Access Compliance Report Public Rights-of-Way (Curb Ramps)

Main Street: COTTAGE_HILL_RD Cross Street: CHIMNEY_LN Location: E

ADA ID: RPRK211101132310 Ramp Type: Type 4 - Parallel Initial Pass/Fail: Fail Overall Compliance: No Severity Score: 32

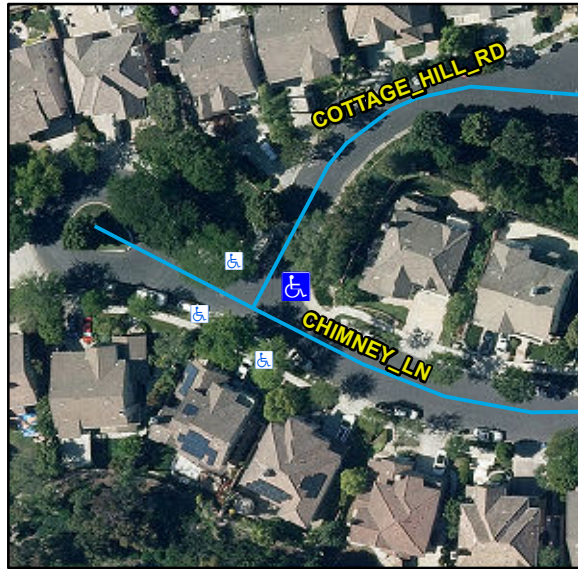
Compliance	Description	Data	Compliance	Description	Data
N/A	Ramp Length LT (in)	86	N/A	Ramp Length RT (in)	93
Yes	Ramp Width LT (in)	53	Yes	Ramp Width RT (in)	53
Yes	Ramp Run Slope LT (%)	0.8	No	Ramp Run Slope RT (%)	14.1
No	Ramp Cross Slope LT (%)	2.7	Yes	Ramp Cross Slope RT (%)	0.5
N/A	Landing Present	N/A	N/A	DWS Provided	N/A
N/A	Landing Length (in)	N/A	N/A	DWS Contrast	N/A
N/A	Landing Width (in)	N/A	N/A	DWS Length (in)	N/A
N/A	Landing Run Slope (%)	N/A	N/A	DWS Full Width	N/A
N/A	Landing Cross Slope (%)	N/A		DWS Offset Type	N/A
N/A	Landing Movement Obstructed?	N/A	N/A	DWS Offset Left (in)	N/A
	Landing Movement Type	N/A	N/A	DWS Offset Right (in)	N/A
N/A	Landing Shared	N/A			
N/A	Clear Space	Yes			
N/A	Clear Space To Crosswalk (in)	N/A			
N/A	Marked Crosswalk 1	No	N/A	Marked Crosswalk 2	No
	Crossing 1 Direction	NW		Crossing 2 Direction	SW
N/A	Marked Crosswalk 1 Width (in)	N/A		Marked Crosswalk 2 Width (in)	N/A

Remove & Replace Curb Ramp With Two New Directional Ramps or Equivalent.
